dsPIC33EPXXXGM3XX/6XX/7XX Family Silicon Errata and Data Sheet Clarification

The dsPIC33EPXXXGM3XX/6XX/7XX family devices that you have received conform functionally to the current Device Data Sheet (DS70000689D), except for the anomalies described in this document.

Data Sheet Clarifications

FIGURE 1: TIMING DIAGRAMS FOR CENTER-ALIGNED AND EDGE-ALIGNED MODES

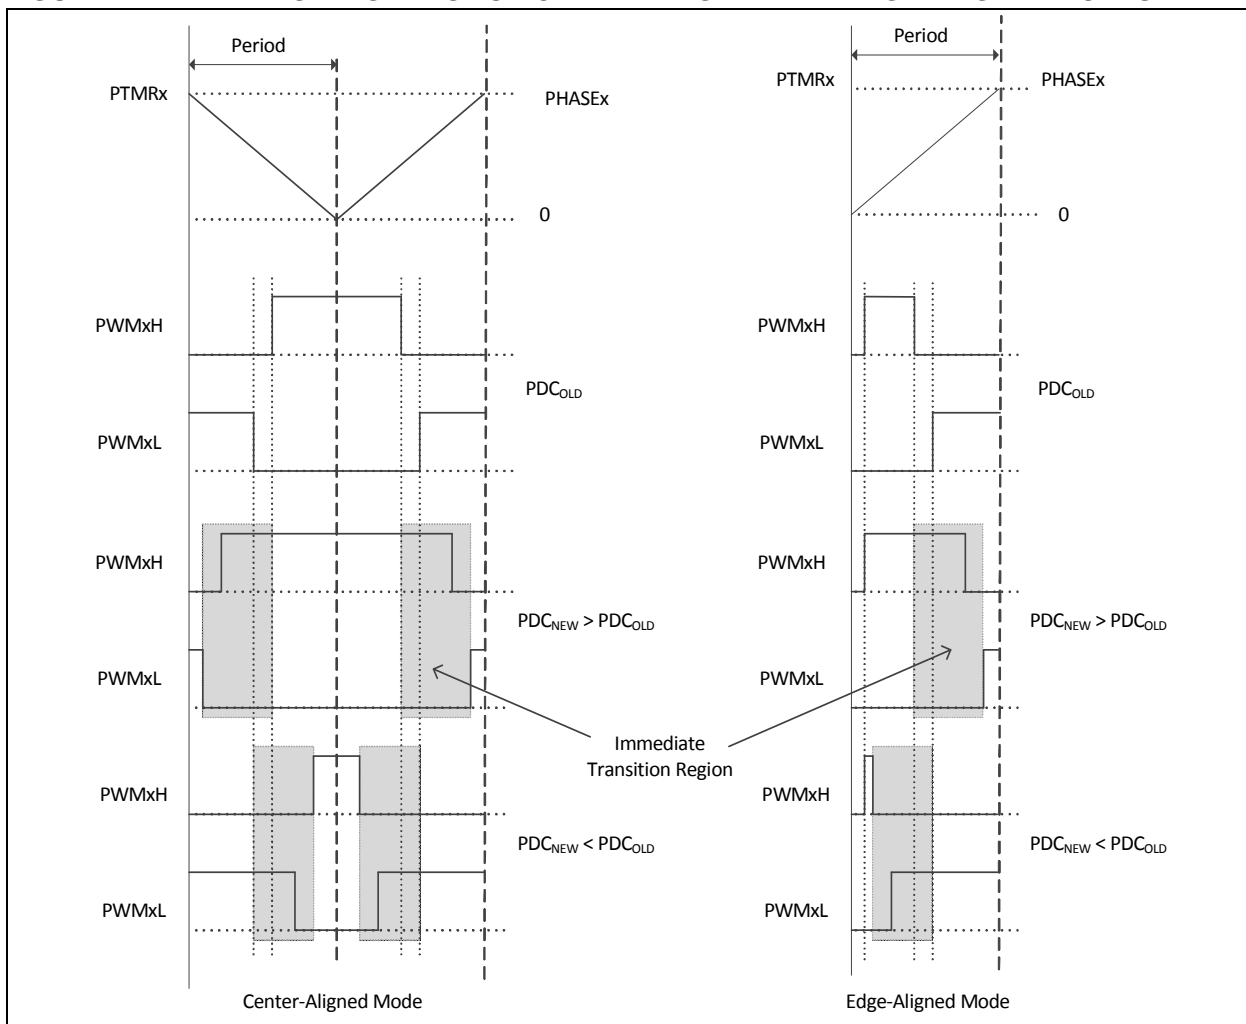
The PWM generator may not assert dead time on the edges of transitions. This has been observed when all of the following conditions are present:

- The PWM generator is configured to operate in Complementary mode with Independent Time Base (ITB) or master time base;
- Immediate update is enabled; and
- The value in the PDC register is updated in such a manner that the PWMxH and PWMxL outputs make an immediate transition.

The current duty cycle, PDC_{OLD}, newly calculated duty cycle, PDC_{NEW}, and the point at which a write to the Duty Cycle register occurs within the PWM

time base, will determine if the PWMxH and PWMxL outputs make an immediate transition. PWMxH and PWMxL outputs make an immediate transition if the Duty Cycle register is written with a new value, PDC_{NEW}, at a point of time when the PWM time base is counting a value that is in between PDC_{NEW} and PDC_{OLD}. Additionally, writing to the Duty Cycle register, close to the instant of time where dead time is being applied, may result in a reduced dead time which is effective on the PWMxH and PWMxL transition edges.

In **Figure 1**, if the duty cycle write occurred in the shaded box, then PWMxH and PWMxL will make an immediate transition without dead time.

None.

In most applications, the duty cycle update timing can be controlled using the TRIGx trigger, or Special Event Trigger, such that the above mentioned conditions are avoided altogether.

FIGURE 2: PWM GENERATOR TIMING DIAGRAM

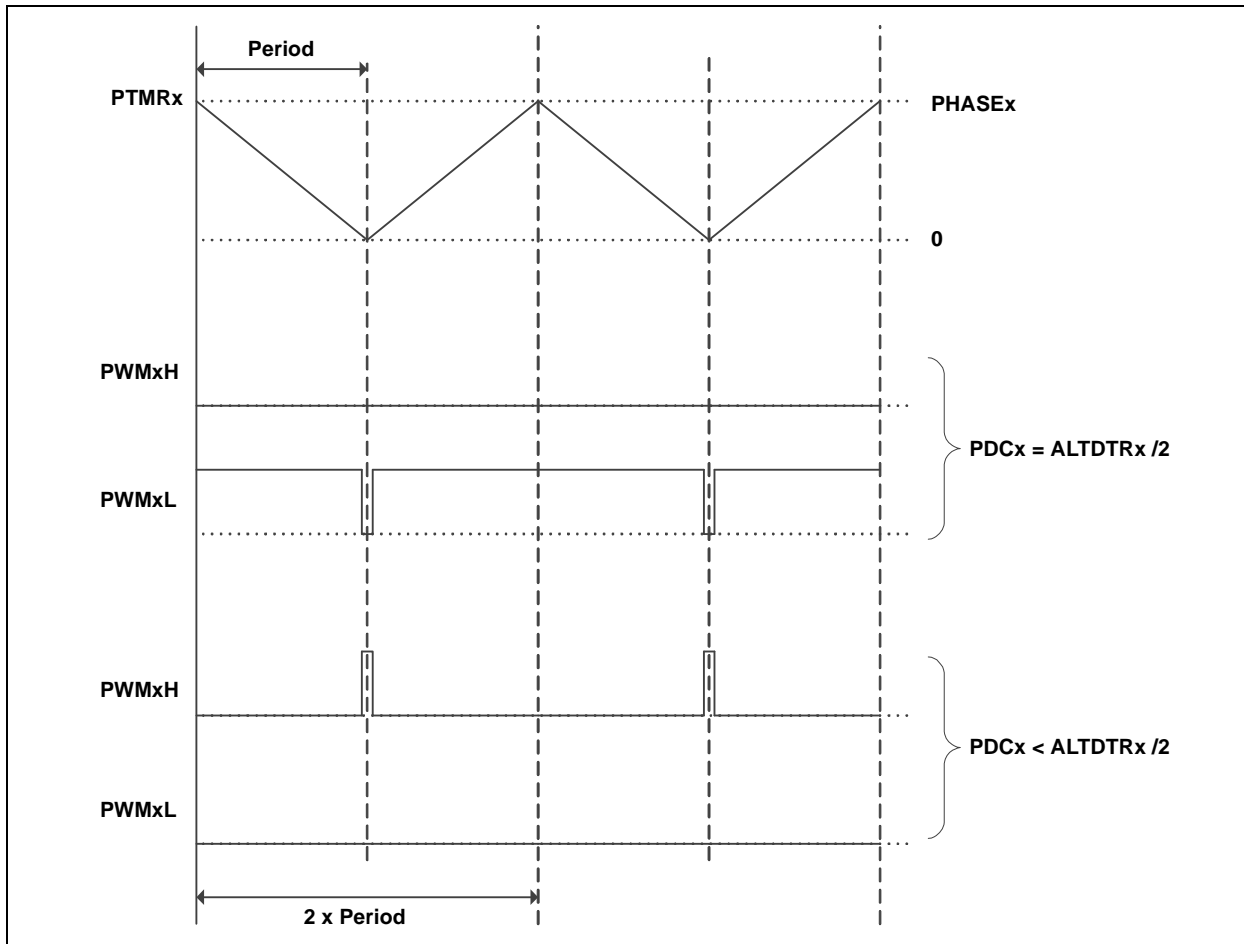
In Center-Aligned Complementary mode with Independent Time Base, if the value in the PDCx register is less than one-half the value in the ALTDTRx register, the PWM generator will force the PWMxL to low, and on the PWMxH, generates pulses of a width less than twice the dead time, as shown in Figure 2.

Include a software routine to ensure that the duty cycle value written to the PDCx register is at least one-half of the value in ALTDTRx. Example 1 shows one method, with PDCtemp representing the variable which has the value to be written to the PDCx register. Alternatively, for duty cycle values less than half the desired dead-time value, zero out the ALTDTRx register or dynamically reduce the value in the ALTDTRx register, such that ALTDTRx is always equal to 2 * PDCx, as shown in Example 2.

EXAMPLE 1: WORK AROUND CODE

```
Altdtr_by2 = ALTDTRx / 2;
if (PDCtemp < Altdtr_by2)
{
    PDCx = Altdtr_by2;
}
else
{
    PDCx = PDCtemp;
}
```

EXAMPLE 2: WORK AROUND CODE

```
#define DESIRED_DEADTIME 100
if (PDCtemp < (DESIRED_DEADTIME/2))
{
ALTDTRx = PDCtemp * 2;
PDCx = PDCtemp;
}
else
{
ALTDTRx = DESIRED_DEADTIME;
PDCx = PDCtemp;
}
```

FIGURE 3:

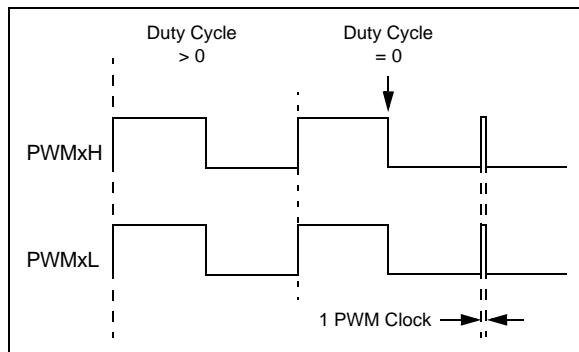
In certain output modes, the PWMx module produces a pulse glitch of one PWM clock in width (Figure 3). This has been observed only when all of the following are true:

- Either Redundant or Push-Pull Output mode is selected ($\text{IOCONx}\langle 11:10 \rangle = 10$ or 01);
- Immediate Update is disabled ($\text{PWMCONx}\langle 0 \rangle = 0$); and
- The value of the current Duty Cycle register (either the PDCx or MDC register, as determined by $\text{PWMCONx}\langle 8 \rangle$) is updated to zero from any non-zero value.

The pulse glitch has been observed to occur at the beginning of the following PWM boundary period.

If the application requires a duty cycle of zero, two possible work arounds are available.

1. Use the PWM overrides to force the output to a low state, instead of writing a '0' to the Duty Cycle register. When using this method, the PWM override must be disabled when the duty cycle is a non-zero value. If output override synchronization is configured to occur on CPU clock boundaries ($\text{IOCONx}\langle 0 \rangle = 0$), enabling and disabling the override must be timed to occur as closely as possible to the PWM period boundary.
2. Configure the module for Immediate Update ($\text{PWMCONx}\langle 0 \rangle = 1$) before enabling the module. In this mode, writes to the Duty Cycle register have an immediate effect on the output. As with the previous work around, writes to the Duty Cycle register must be timed to occur as close to the PWM period boundary as possible in order to avoid distortion of the output.

FIGURE 4:

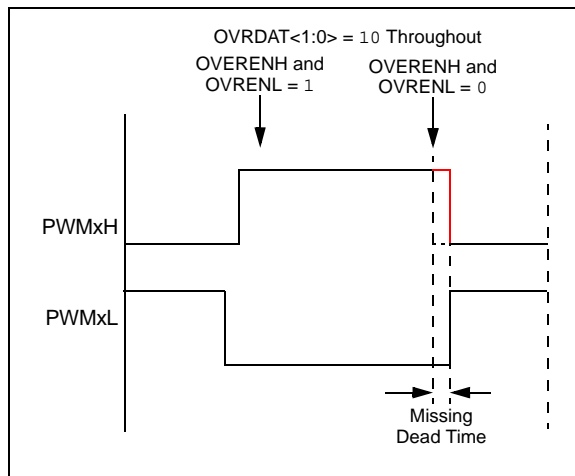
In Complementary Output mode, the expected dead time between transitions of the PWMxH and PWMxL outputs may not be asserted when the following occurs:

- Output override synchronization is configured to occur on the CPU clock boundary ($\text{IOCONx}\langle 0 \rangle = 0$);
- Both PWMxH and PWMxL overrides are enabled prior to the event (OVRENH and OVRENL are both '1'), and
- Both overrides are disabled (OVRENH and OVRENL are both '0') at the instant the dead time should be asserted (Figure 4).

This has been observed in both Center-Aligned and Edge-Aligned modes.

None.

FIGURE 5:

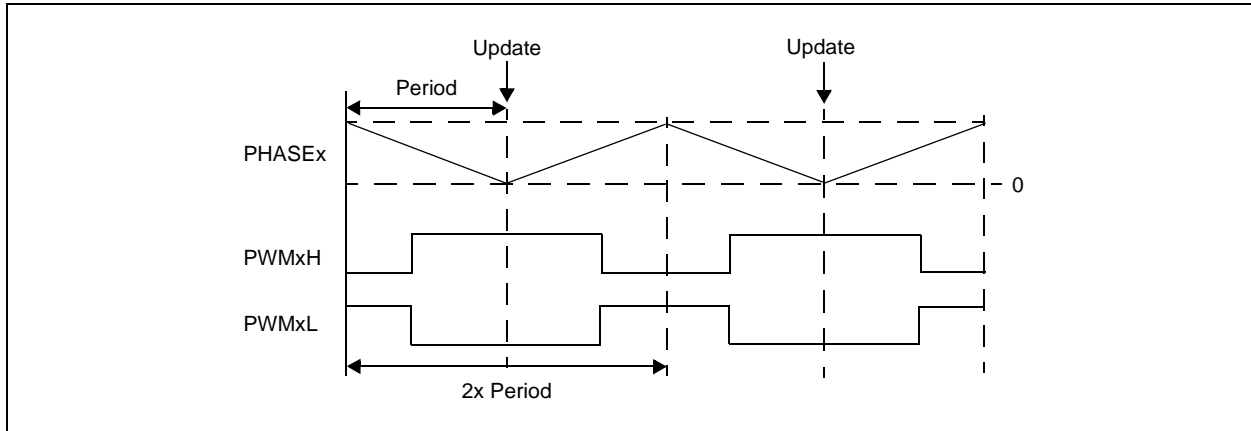
In Center-Aligned Complementary mode with Independent Time Base, updates to the PHASEx register take effect in the middle of a Center-Aligned PWM cycle, as shown in Figure 5. This occurs only when the Immediate Update feature is disabled (IUE = 0). If Immediate Update is enabled (IUE = 1), the PHASEx register updates will take effect immediately.

None.

FIGURE 6:

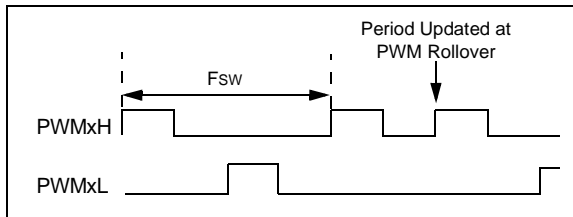
When the PWM module is configured for Push-Pull mode (IOCON<11:10> = 10) with the Enable Immediate Period Update bit enabled (PTCON <10> = 1), a write to the Period register that coincides with the period rollover event may cause the push-pull output logic to produce back-to-back pulses on the PWMx pins (Figure 6).

Ensure that the update to the PWM Period register occurs away from the PWM rollover event by setting the EIPU bit (PTCON<10> = 1). Use either the PWM Special Event Trigger (SEVTCMP) or the PWM Primary Trigger (TRIGx) to generate a PWM Interrupt Service Routine (ISR) near the start of the PWM cycle. This ISR will ensure that period writes do not occur near the PWM period rollover event.

64-Lead Plastic Quad Flat, No Lead Package (MR) – 9x9x0.9 mm Body with 5.40 x 5.40 Exposed Pad [QFN]

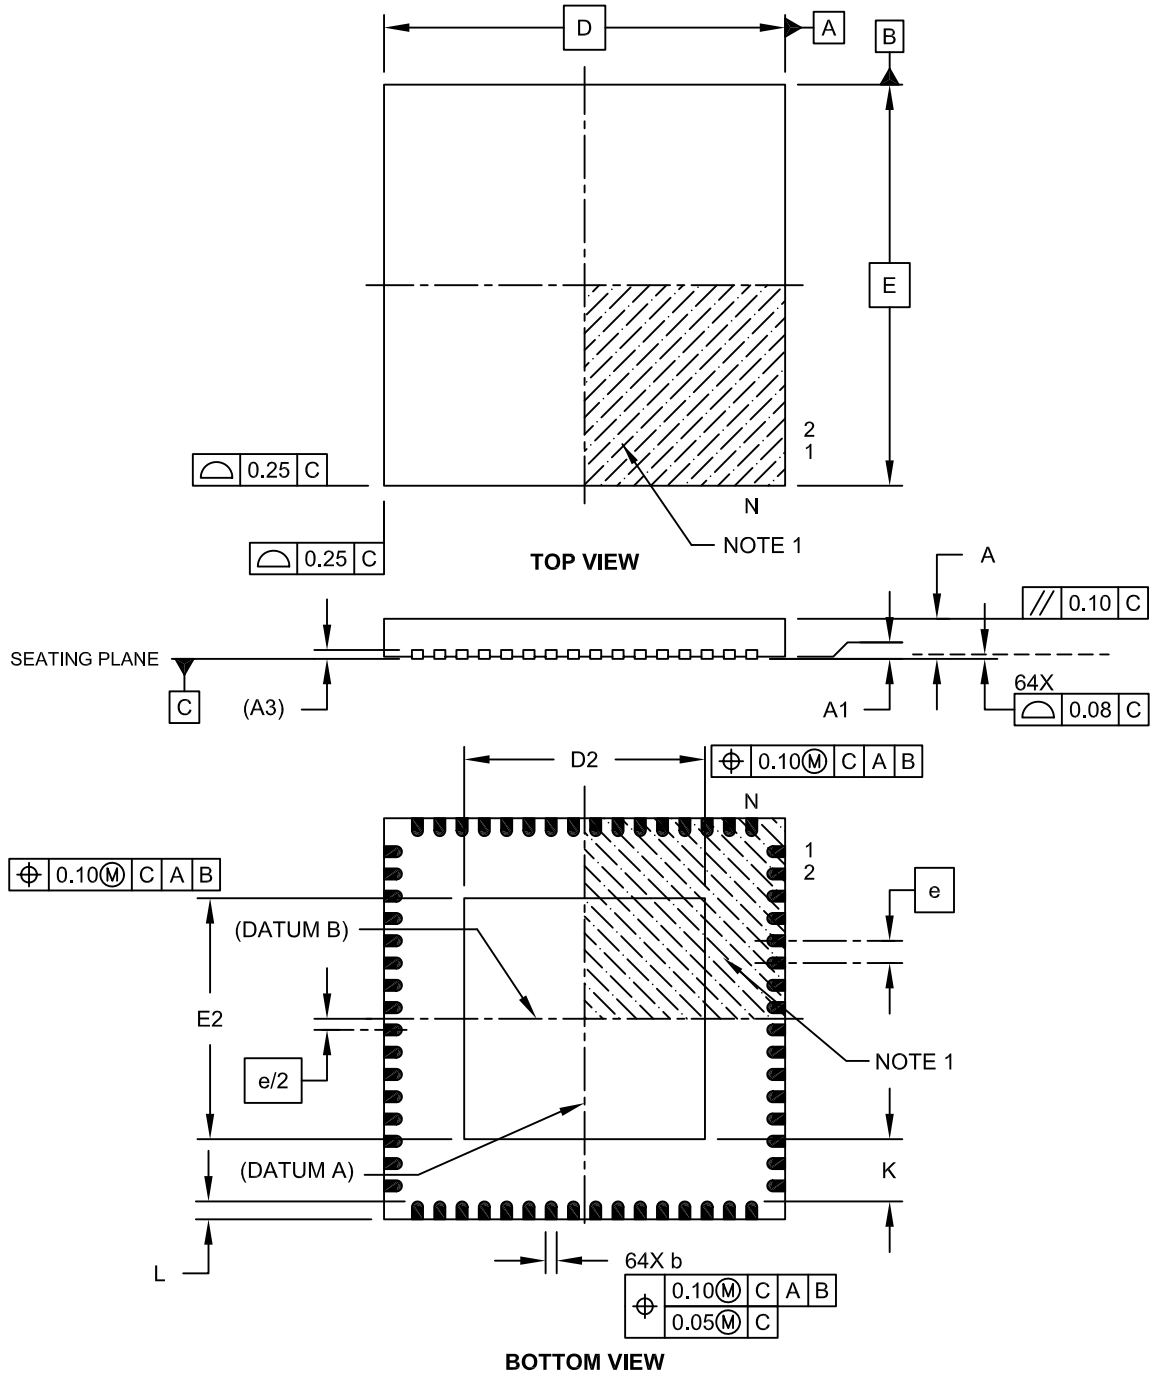
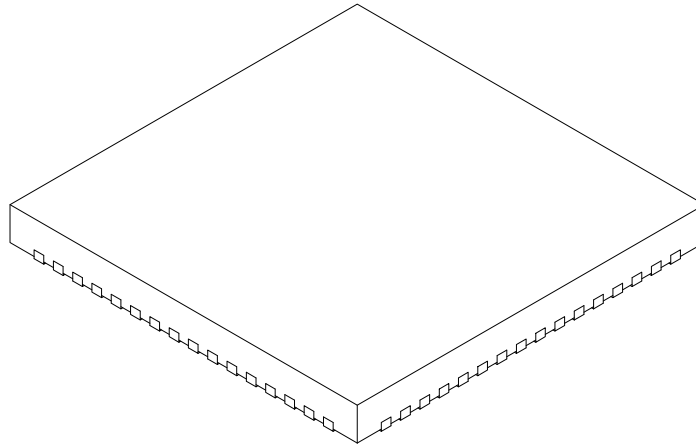
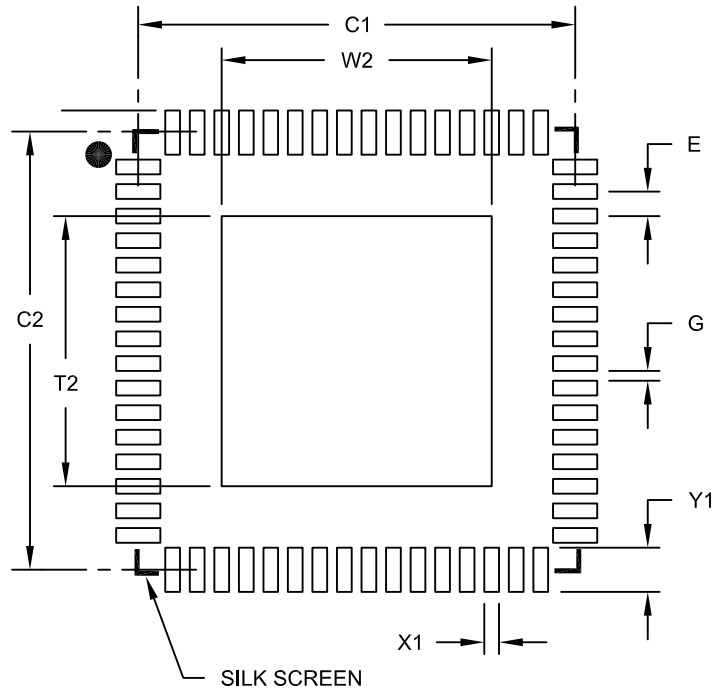
In the “*dsPIC33EPXXXGM3XX/6XX/7XX Family Data Sheet*”, **Section 35.2 “Package Details”**, dimensions for the 64-Lead Plastic Quad Flat, No Lead Package (MR) – 9x9x0.9 mm Body with 7.15 x 7.15 Exposed Pad [QFN] is mentioned. However, the dsPIC33EPXXXGM3XX/6XX/7XX family devices are not available in this package.

The dsPIC33EPXXXGM3XX/6XX/7XX family devices are available in the 64-Lead Plastic Quad Flat, No Lead Package (MR) – 9x9x0.9 mm Body with 5.40 x 5.40 Exposed Pad [QFN], and the package dimensions are shown on the following pages.
